A D D E N D U M #2

Project	Nelson H.S. Renovations	**Project No.**	2323
Location	4181 New Street, Burlington, Ontario	**Date of Issue**	2024 05 30
Owner	The Halton District School Board	**File**	2323/7.1.3

This Addendum forms part of the Contract Documents and amends the original Drawings and Specifications, dated 2024 05 13, as noted below.

1 / E200 **GROUND FLOOR (EAST WING) DEMOLITION LAYOUT (PART 1/2)**
1:100

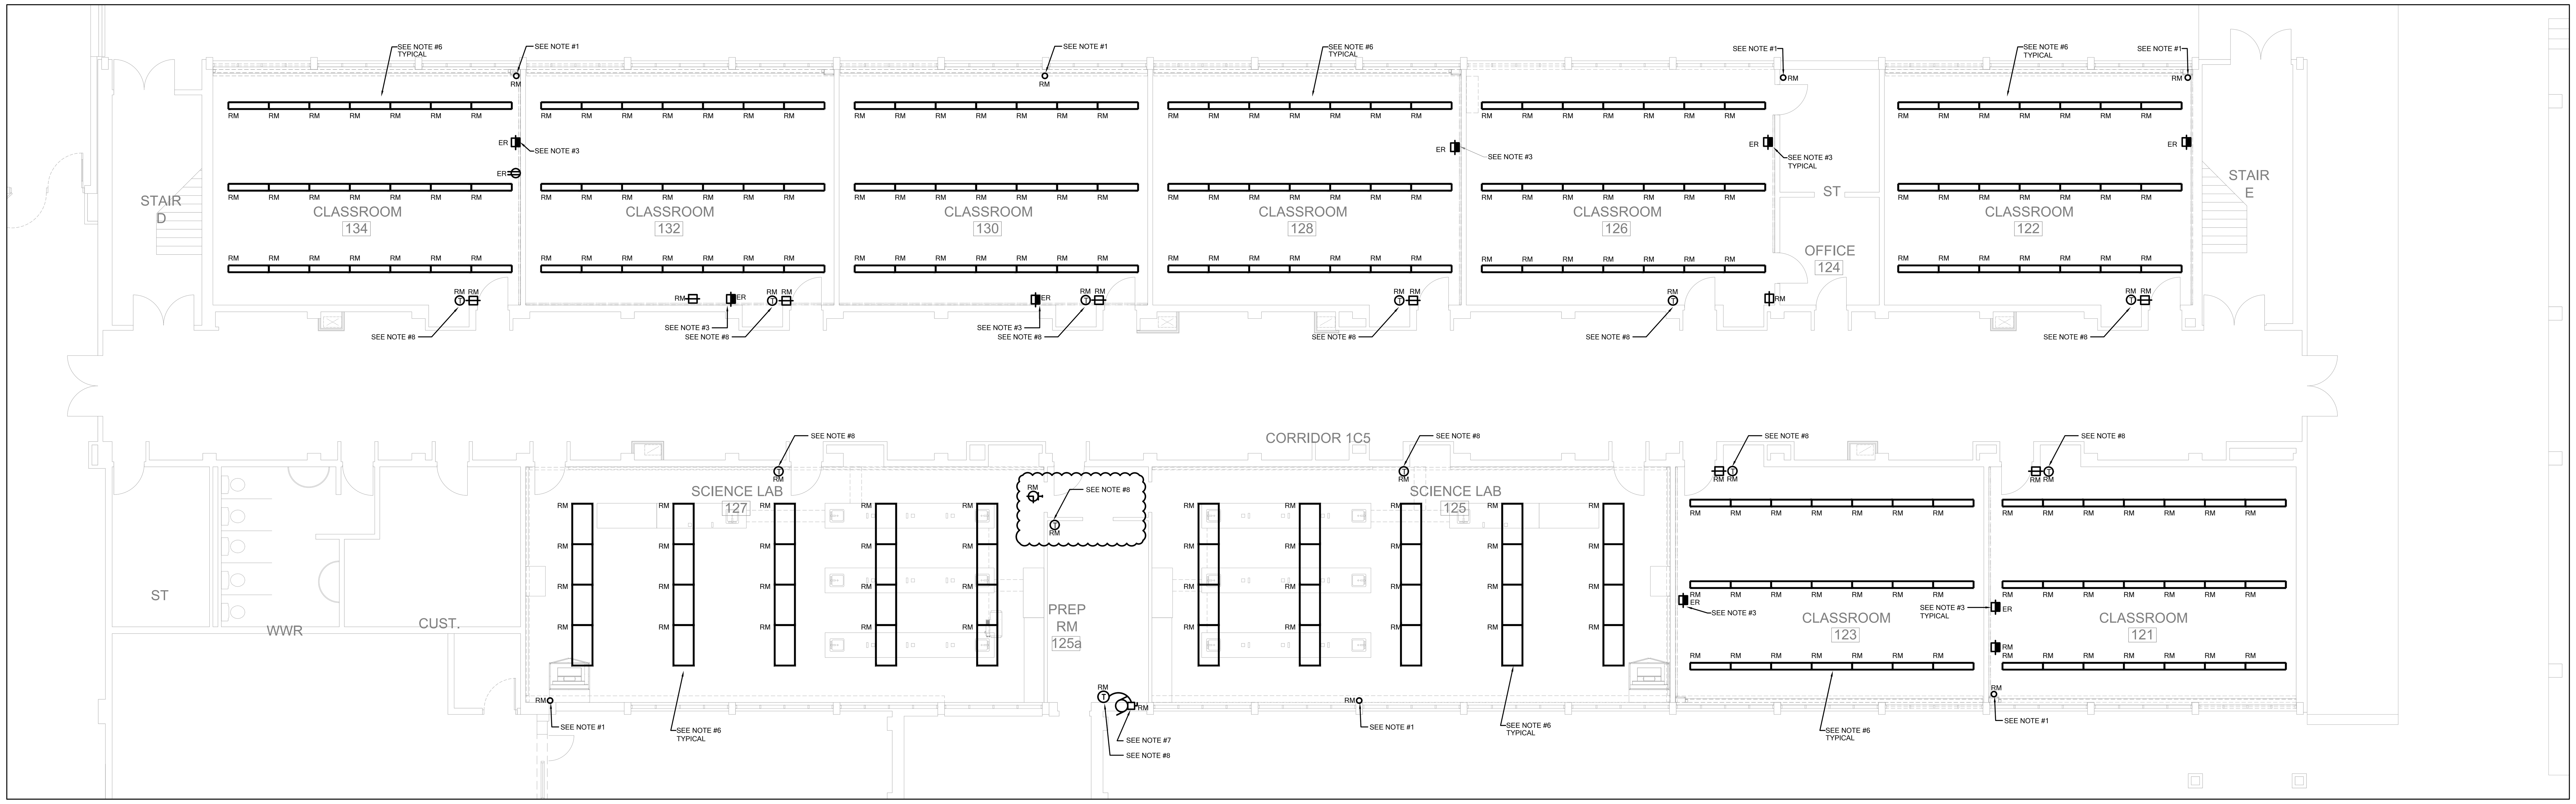
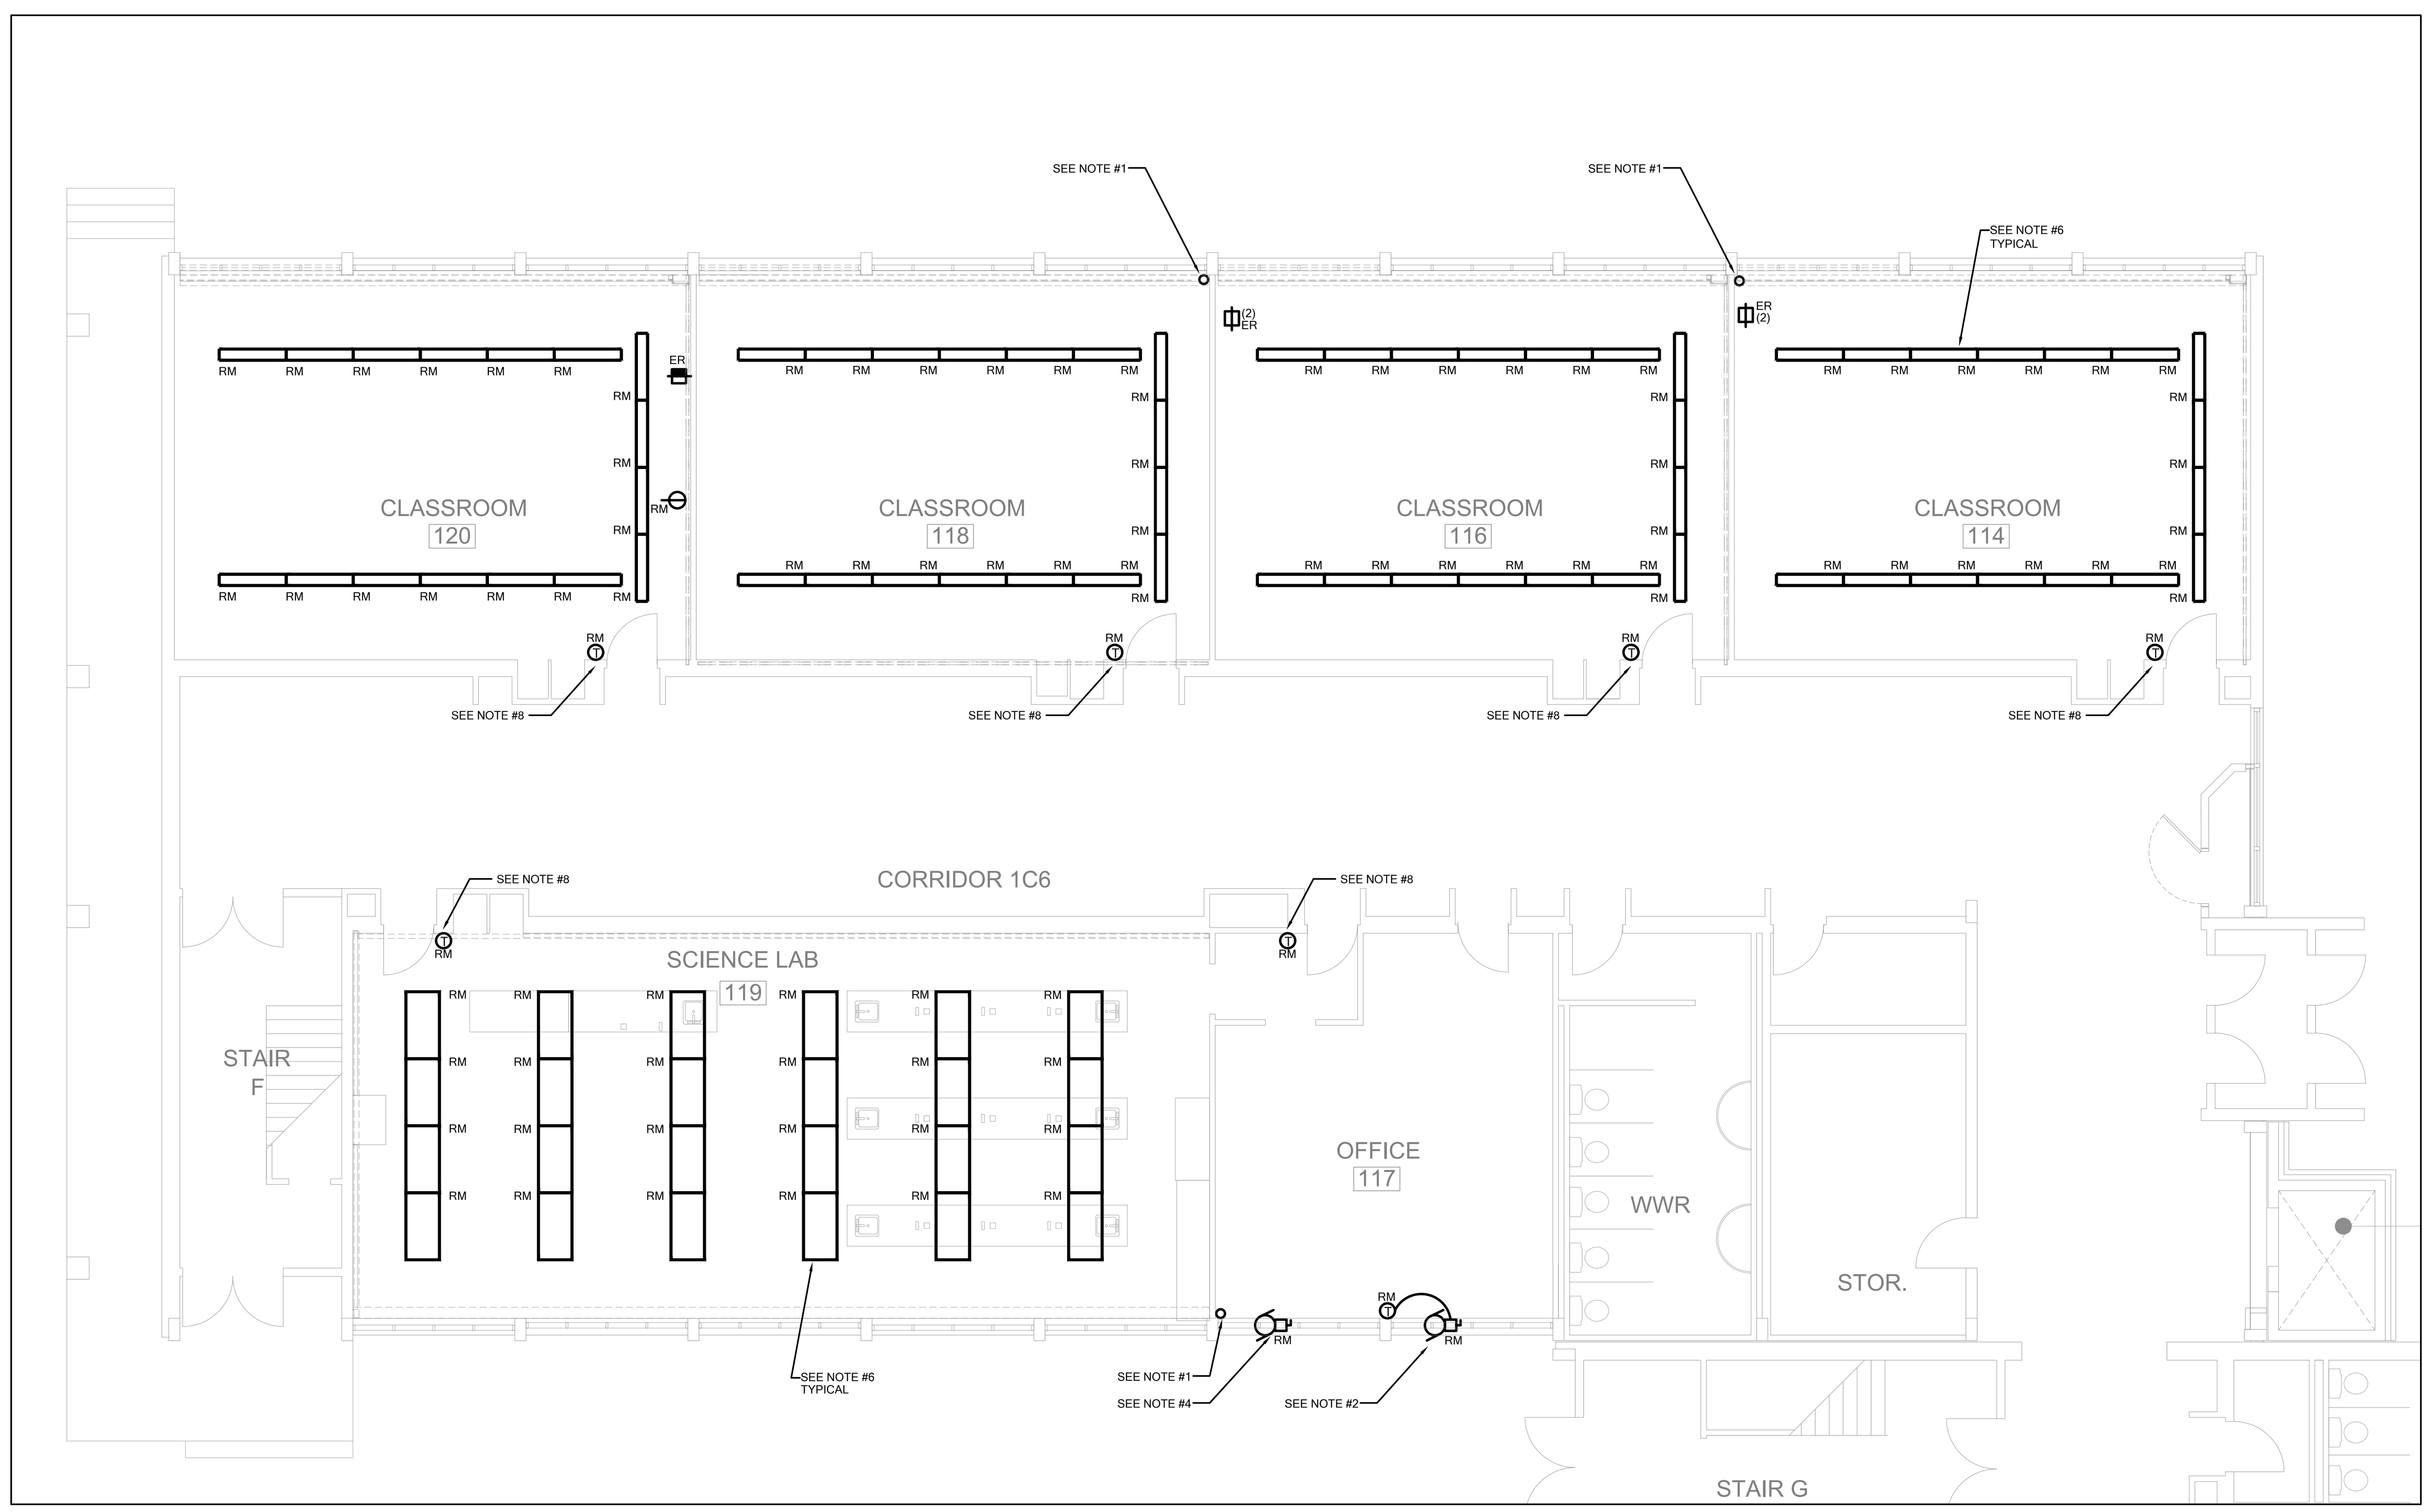
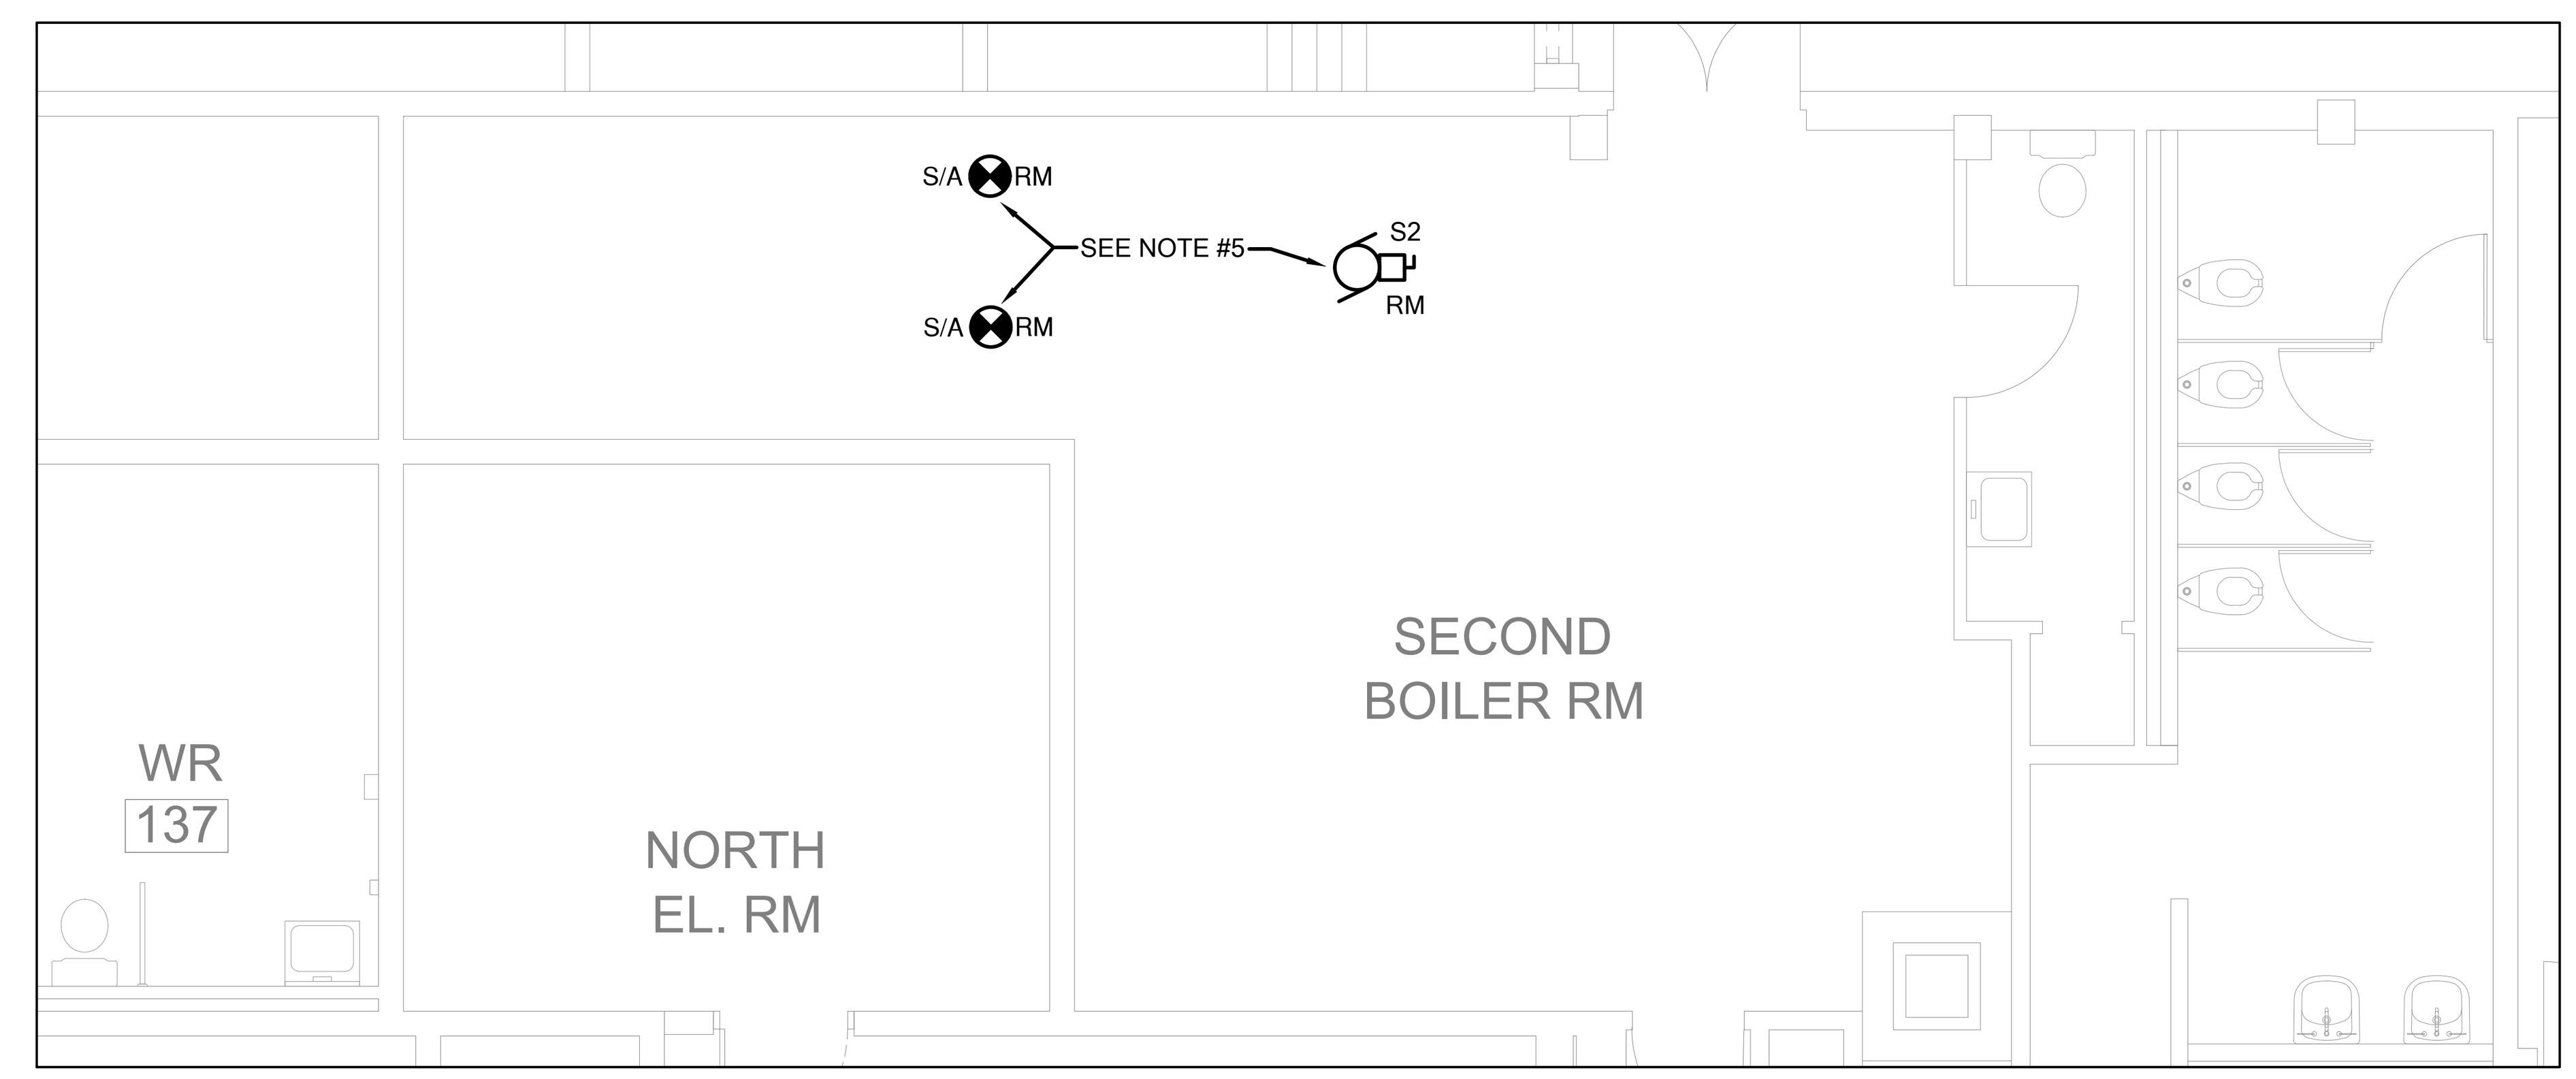
.1 Refer to Drawing E200 and include the changes indicated.
- Updated location of temperature sensor to be removed.
- Added clock to be disconnected and removed and all associated conduit and wiring. Maintain existing clock system wiring continuity.

1 E201 **GROUND FLOOR (SOUTH WING) DEMOLITION LAYOUT (PART 1/2)**
1:100

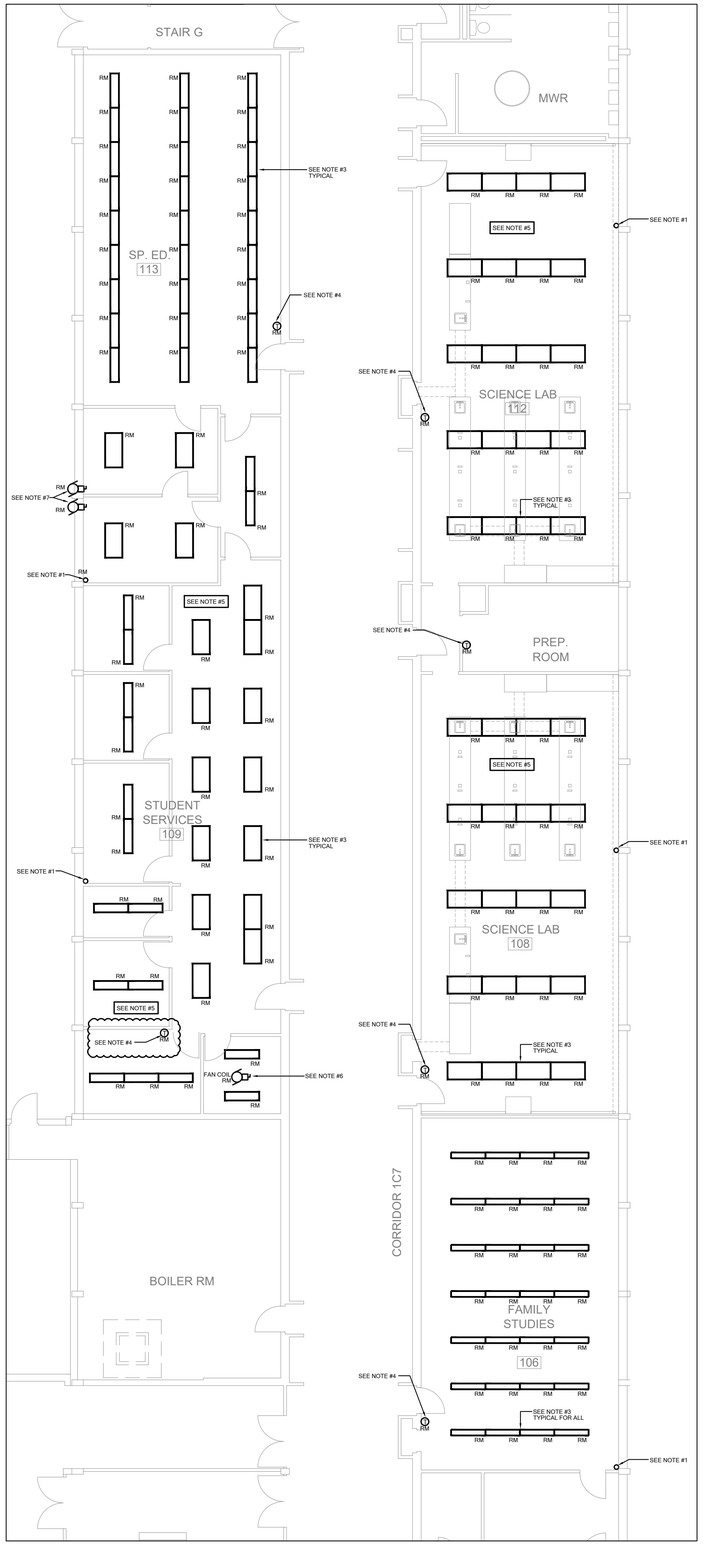
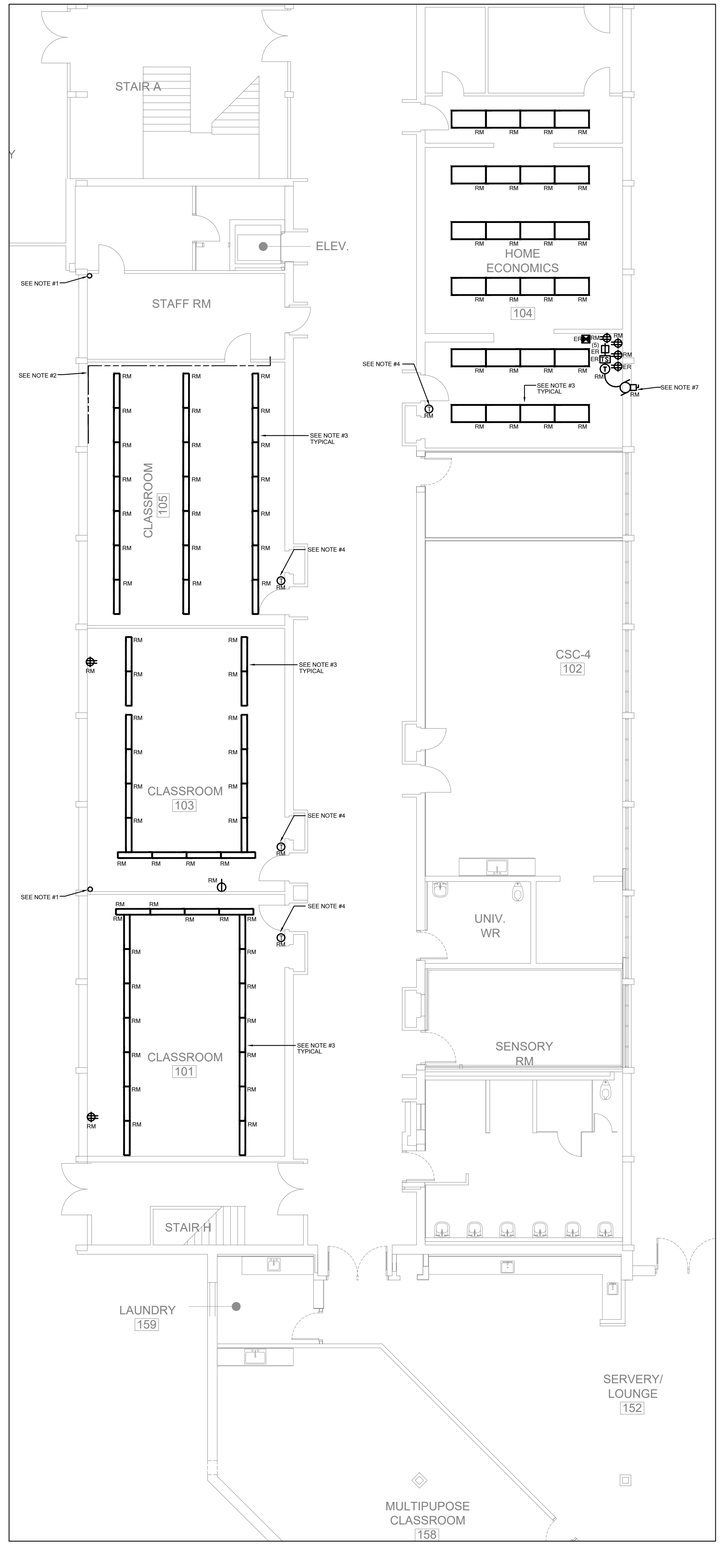
.1 Refer to Drawing E201 and include the changes indicated.
- Added temperature sensor to be removed in Student Service #109.
